SERVICE BULLETIN

NO. 200-002

REV. "C"

1. SUBJECT : Inspection and modification of rudder pedal operation.
2. AIRCRAFT AFFECTED : All FA-200 series aircraft S/N 12 thru. 297.
3. PRIORITY : Mandatory
4. REASON : To prevent overtravel of rudder pedal and to ensure proper operation of rudder control system, this bulletin specifies inspection and modification if required.
5. DESCRIPTION : (1) Inspection - Rudder Pedal Stop

Fig. 1. RUDDER PEDALS AND RELATED COMPONENTS

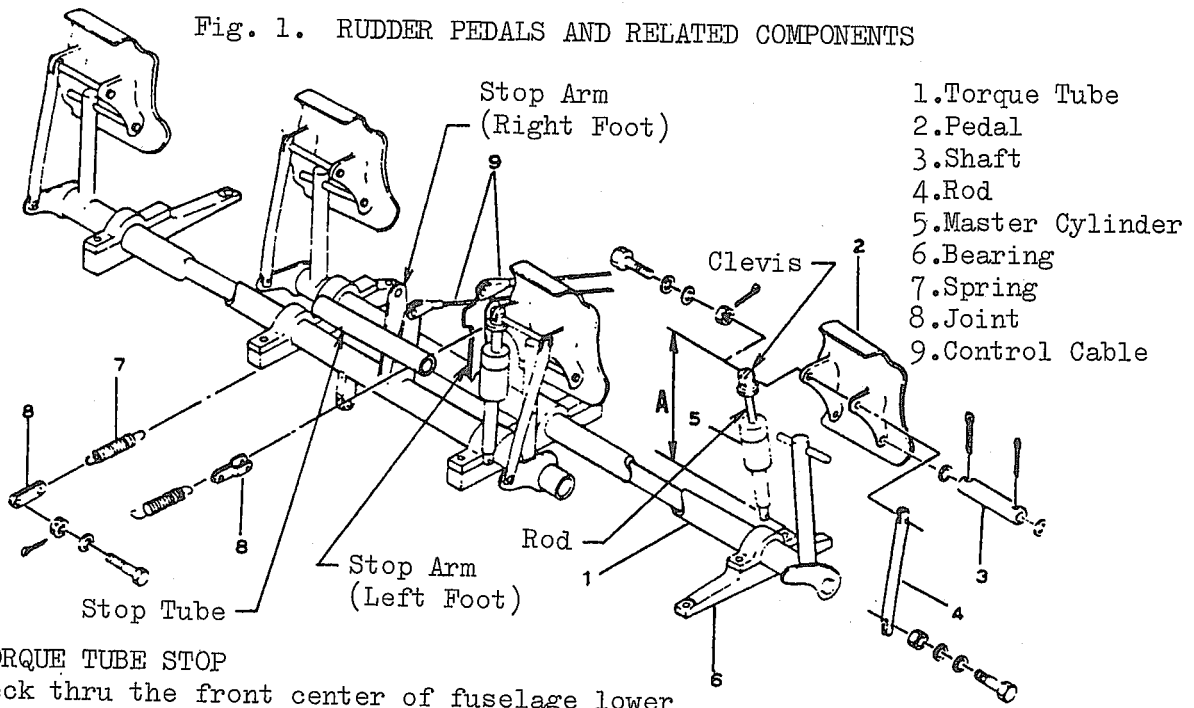
Check left (foot) and right (foot) rudder pedal stops for clearance within specified hours described in "6, ACCOMPLISHMENT" after receipt of this bulletin. Under properly adjusted condition, stop clearance with full rudder travel should be 5mm(0.2in) or less for left pedal and 2.5mm(0.1in) or less for right pedal. Corrective action per para 12 of this bulletin is required if these limits are exceeded.
- (2) Inspection - Brake Master Cylinder Length (Affected Brake Master Cylinder: P/N 0541138-20)

Brake master cylinder is to be adjusted to length as short as possible within range not interfering with rudder pedal tabs. Dimension between both centers of bolt holes should be 204.5 mm (8.05 in) or less. It is required to shorten rod end if measurement is more than 204.5 mm. Details are described in section 12 of this bulletin. These reworks should be accomplished within specified hours described in section 6 of this bulletin.
- (3) Inspection - Brake Link Over-center Force
Note: This inspection is not required after compliance with Technical Bulletin 200-022.

Full length of "A" should be 204.5mm(8.05 in) or less.

- (2) Check clevis for proper thread engagement.
- (3) Length between bolt hole centers at both ends should be 204.5 mm (8.05 in) or less in the fully extended position.
If any interference is noted by this adjustment between rudder pedal and clevis rod end, trim the rod end to provide clearance.

Fig. 2. STOP TUBE MODIFICATION

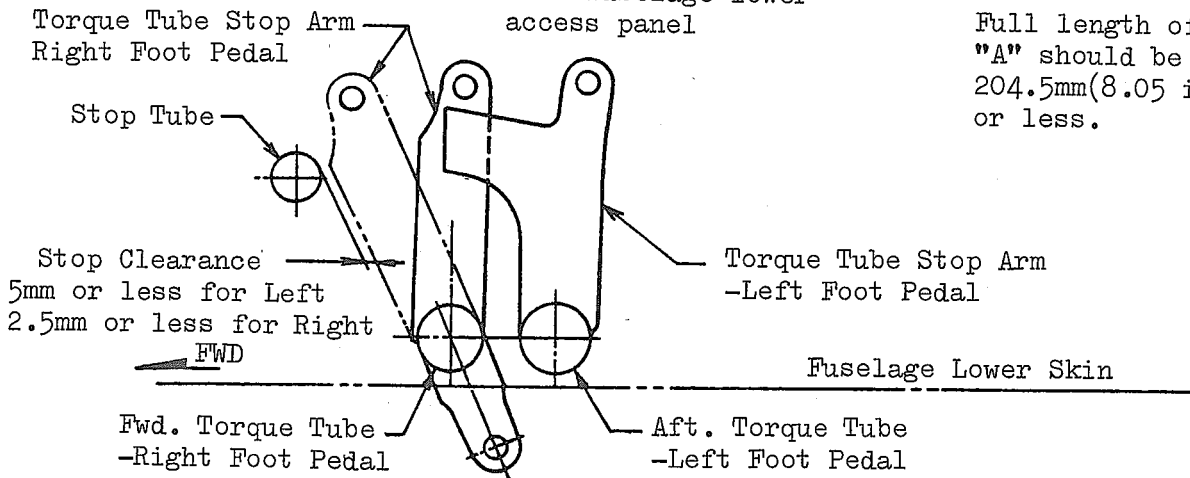
- (5) Remove stop tube and install collar assy as shown in Fig. 2, if the measured stop clearance still exceeds 5 mm (0.2 in) for left and 2.5 mm (0.1 in) for right after step (4) is performed.
Removal of stop tube can be accomplished by removing either one of cotter pins.

Make thru hole ($\frac{.128}{.125}$ in) as shown in Fig. 2 and apply zinc chromate primer or equivalent corrosion preventive paint to the holes.

Left Fig. shows right foot pedal stop collar installation. Left pedal stop collar is installed on opposite side of center line.

- (6) Install stop tube with properly matched collars. Tube and collar should be secured with cotter pin.
- (7) Recheck stop clearance and then reinstall removed parts.

Fig. 3. OPERATIONAL CHECK - BRAKE LINK OVER-CENTER FORCE

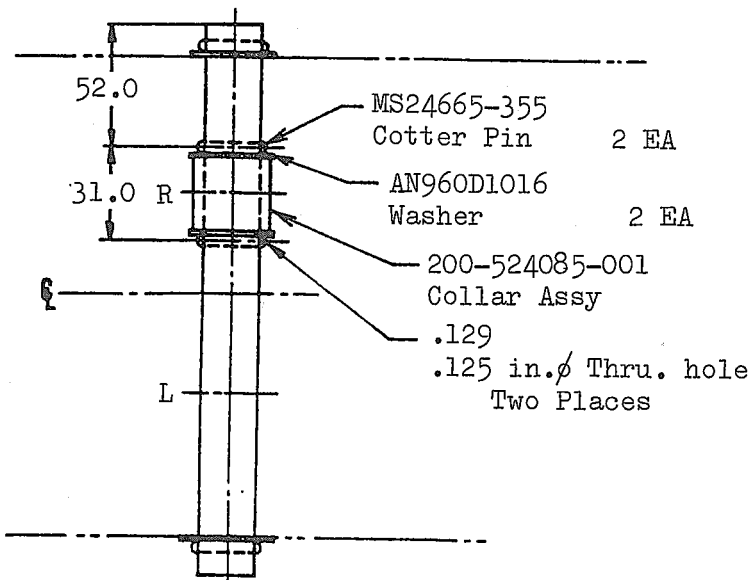
With rudder pedal stop arm contacting stop tube, brake link bolt is pulled with 20 kg force. The brake link should not be over-

centered (go beyond dead center).
(See Fig. 3 and para 12 for detailed instructions.)

- (1) Install wire around brake link connecting bolt as shown in Fig. 3.
- (2) For each of left and right rudder pedals, apply full rudder pedal until its stop arm contacts stop tube. In this condition, pull brake link bolt with 20 kg force as shown in Fig. 3. The brake link should not be over-centered (go beyond dead center).
- (3) If the above check reveals over-centering, inspect link detailed parts for wear and other damages. Replace defective part(s) and repeat operational check per above step (2).
